EAST WHITELAND TOWNSHIP – ACT 537 PLAN DOCUMENTS
(PLANNING MODULES)

Re: Approval Letter – Minor Act 537 Plan Update
Planebrook Road Area Sewer Extension
Component 3m
Status: ISSUED
APS No. 38912, Site ID No. 518980
East Whiteland Township
Chester County

RE: East Whiteland Township Act 537 Component 3m
Response to November 19, 2020 Review Comments.
Planebrook Road Area Sanitary Sewer Extension.
ARRO# 10310.36

Sewer Extension Plan Sheets

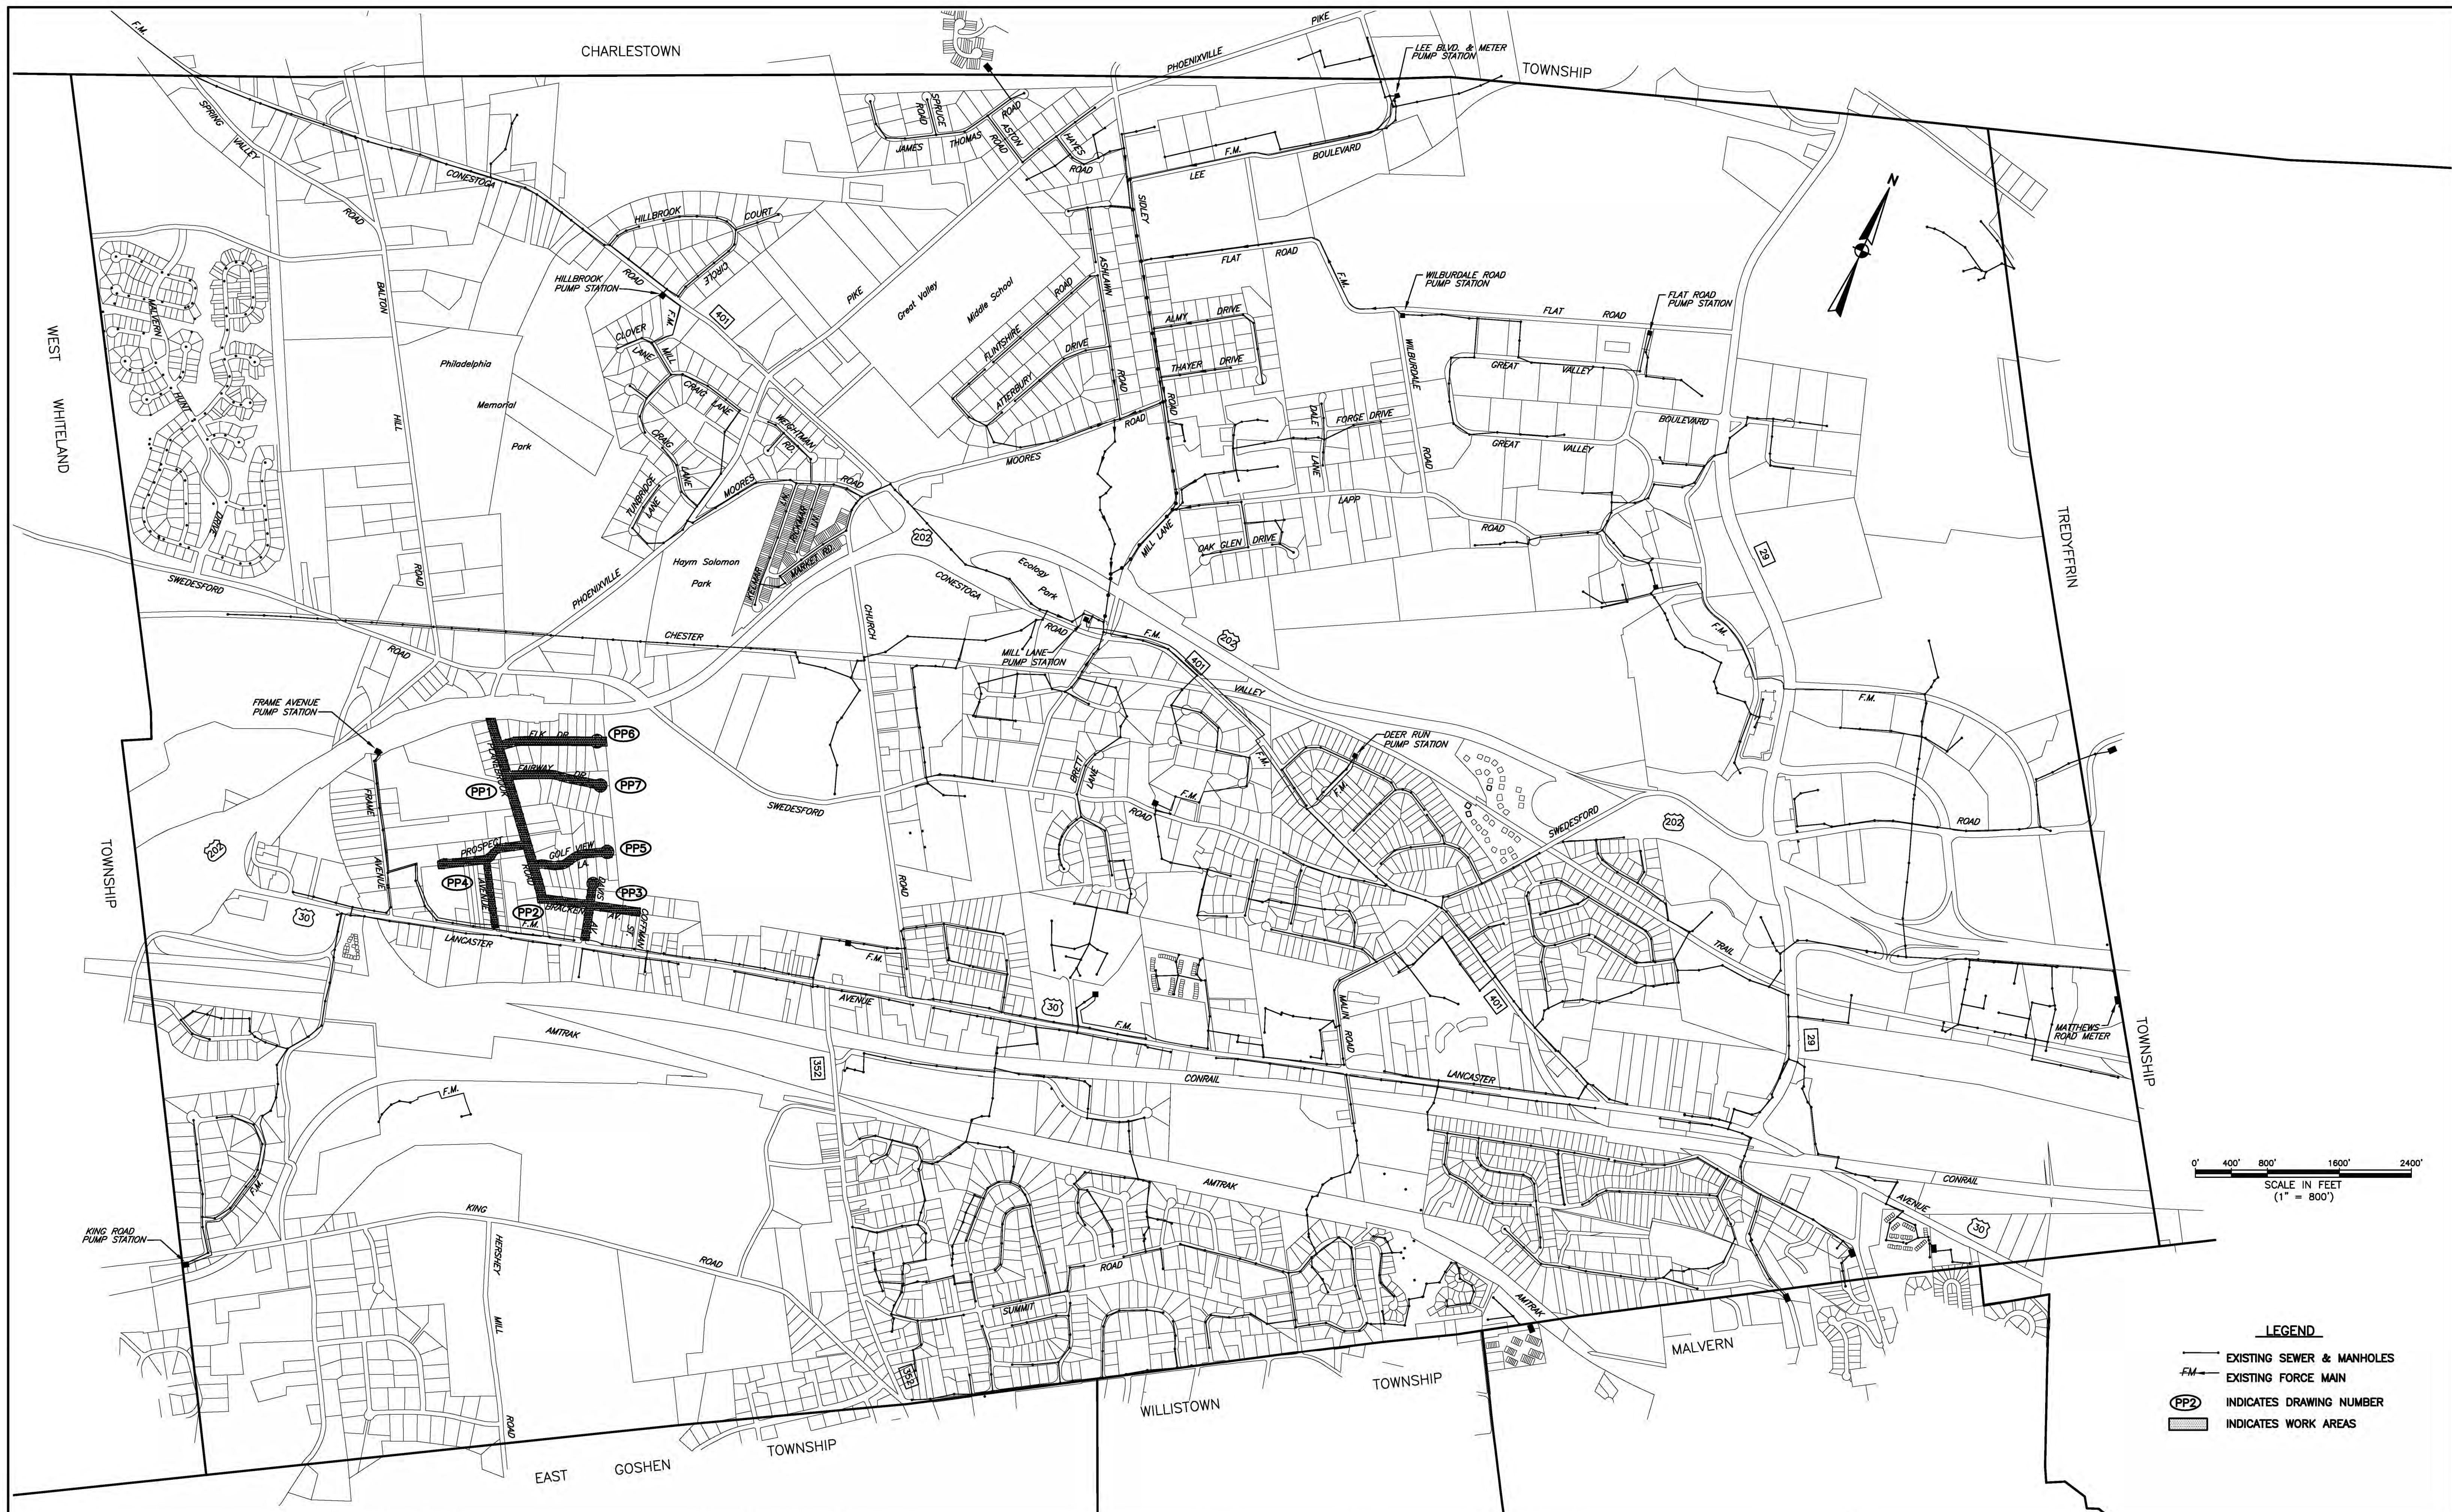
A plan of the Township's sewer system was provided but it did not provide the information requested in Item 5 of our September 24, 2020 review letter. Specifically, it did not show the location of the new Planebrook Regional Pump Station or its associated force main which is proposed to convey the sewage from the proposed collection sewers. Please provide a general map showing the path of the sewage from the point at which it connects into the existing sewer system to the receiving treatment plant.

Please see the attached plans for your reference.
